Docket Item # 7
BAR CASE # 2009-0081

BAR Meeting
May 20, 2009

ISSUE: Alterations
APPLICANT: Jennifer Barnes
LOCATION: 10 Irving Court
ZONE: CL / Commercial

Figure 4. Proposed window specifications.

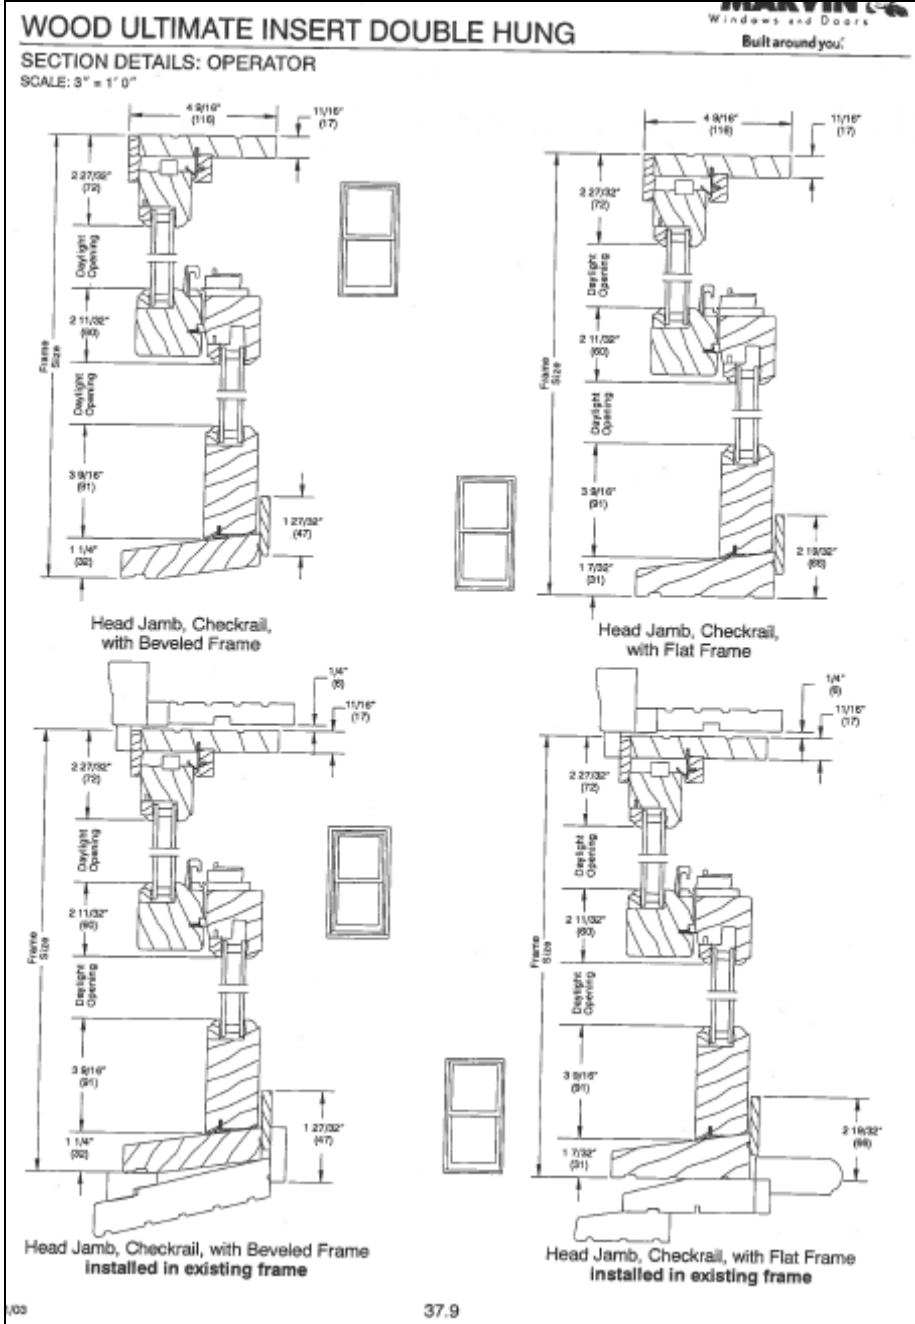
windows, with interior spacers and applied muntins would be generally acceptable. The building is located entirely on a public alley and has minimal visibility from public streets. However, Staff is concerned that the proposed replacements are window inserts rather than complete sash replacements. Window inserts, or the installation of a new frame and window inside an existing frame, significantly alter the existing fenestration as they decrease the size of the daylight opening and increase the area of frame. In circumstances where window inserts have been used, the fenestration becomes reduced in size and out of proportion. Staff finds that simulated divided light, double-glazed wood windows are acceptable but recommends that they be a complete sash replacement rather than replacement window inserts.

Staff recommends that the application be approved with the condition that replacement windows (complete sash replacement) be used instead of replacement window inserts, with final window specifications to be approved by Staff prior to the applicant ordering the replacement windows.

Figure 6. Proposed window specifications, divided light options. Application is proposing insulated glass with 7/8" SDL and spacer bar.

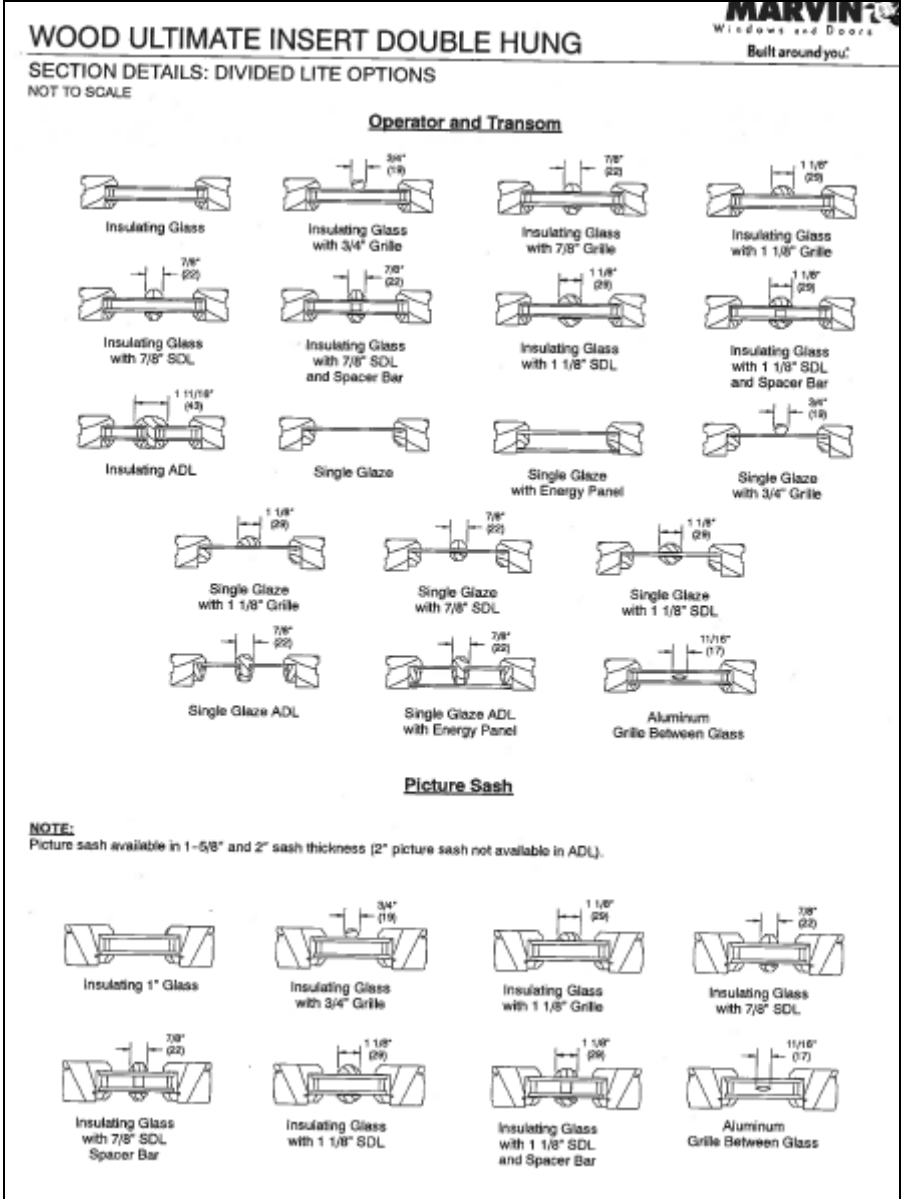
The applicant is requesting approval of a Certificate of Appropriateness for replacement window inserts at 10 Irving Court. The existing windows are true divided light, singled-glazed wood windows. The proposed replacement windows are simulated divided light wood window inserts to match the existing in light configuration. The proposed windows will have a 7/8 inch muntin with an interior spacer bar and exterior applied wood muntins.
